ADDRESS: 1900 S 16TH ST

Proposal: Convert church complex to multi-family residential and event space use

Review Requested: Final Approval

Re: Adaptive Reuse True Gospel Tabernacle Family Church
1900 S 16th Street, Philadelphia, PA 19145

02 TOWER WEST ELEVATION - PROPOSED Copy 1
12/11/24

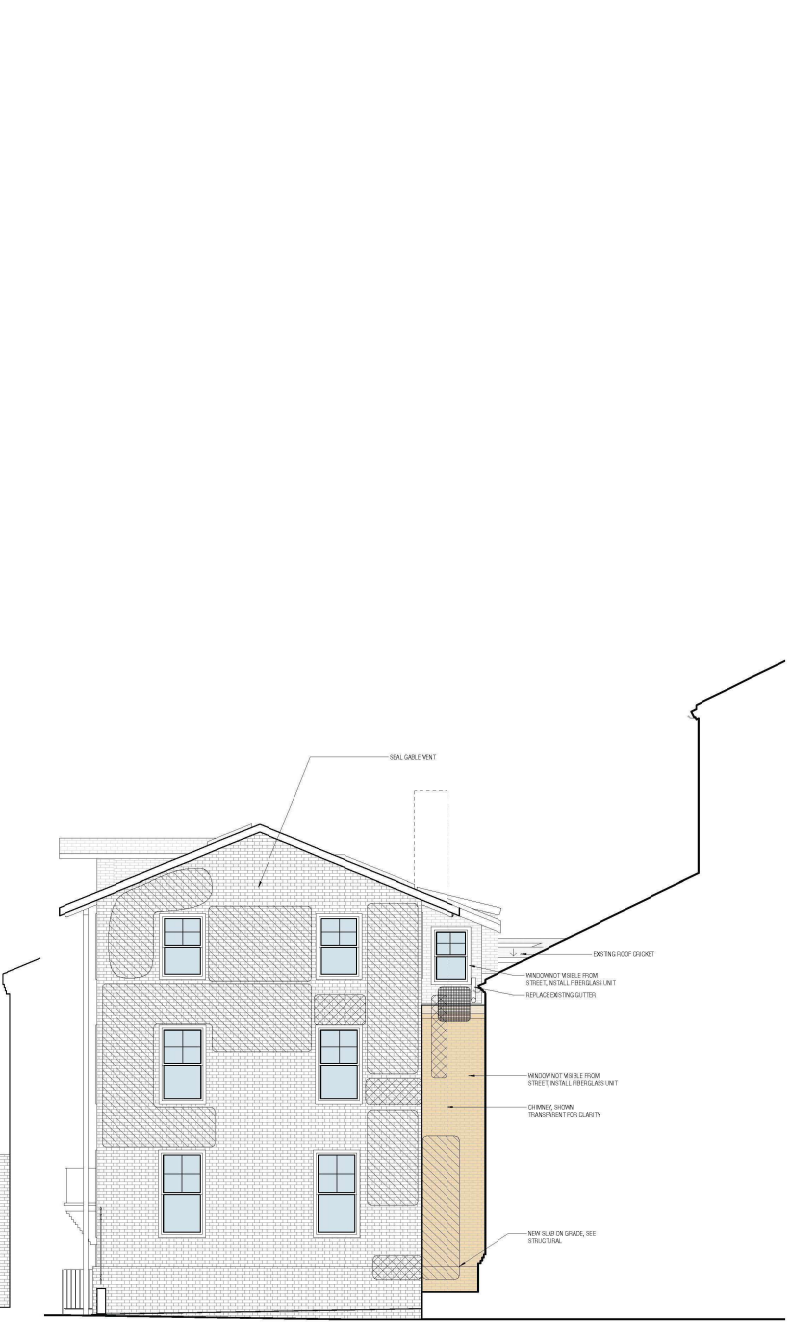
STAFF RECOMMENDATION: Approval, provided the removed stained glass windows are stored in a secure location, the cupola is retained, and the new door and window in the tower are reconsidered, with the staff to review details, pursuant to Standard 9 and the December 2021 Historical Commission approval of a similar scope.
